DOE/NASA TECHNICAL
MEMORANDUM

DOE/NASA TM-78182

DEVELOPMENT, TESTING, AND CERTIFICATION OF LIFE SCIENCES
ENGINEERING SOLAR COLLECTOR -- FINAL REPORT

At each review, questions and comments about the design were recorded on a standard MSFC Form No. 487, "Review Item Discrepancy" (RID). The contractor provides a response to each RID. Four RID's were written by NASA against the preliminary design, thirteen against the prototype design, and four (none involving hardware design) against the final design as represented by the first (production) article. Copies of all RID's and responses are included as Appendix B.

INSTALLATION OF INSULATION
& FLASHING

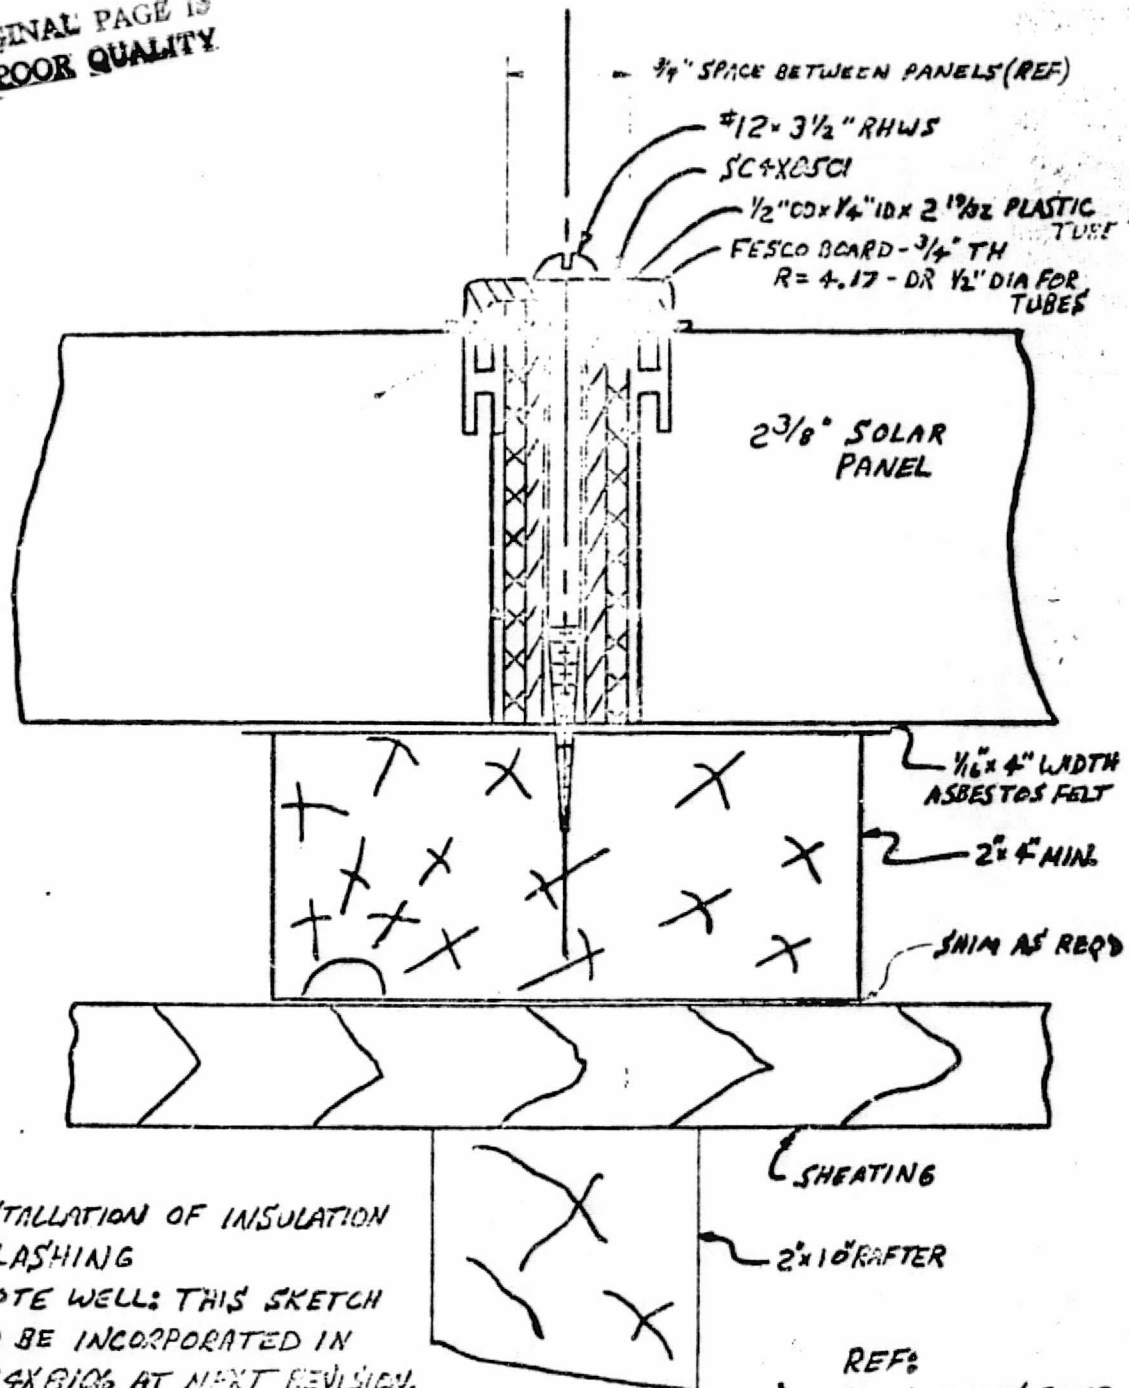
Dwg No. SC4x8106 Sheet 2

The cover flashing as showing is crimping the tedlar covers. It should be made as to not bear directly on the tedlar. Tedlar crimped between 2 pieces of metal would be very suspect to failure at this point. If more details had been drawn on this drawing, the above would have been more obvious.

ACTION TAKEN: The rigid plastic/fiberglass 'U' channel discussed at the 5/24 Technical Conference will provide the necessary strength to hold down the Fesco board. A 2 5/8" rigid plastic standoff tube will maintain proper pressure on the gasket/Tedlar interface.

ACTION TAKEN: Revised drawing SC4X8106 Sheet 2 shows a 1 1/4" plastic/fiberglass 'U' channel for the flashing. It will hold down the Fesco board. Where the 'U' channel/Fesco board interfaces with the H-Bar/Tedlar, gaskets will be used.
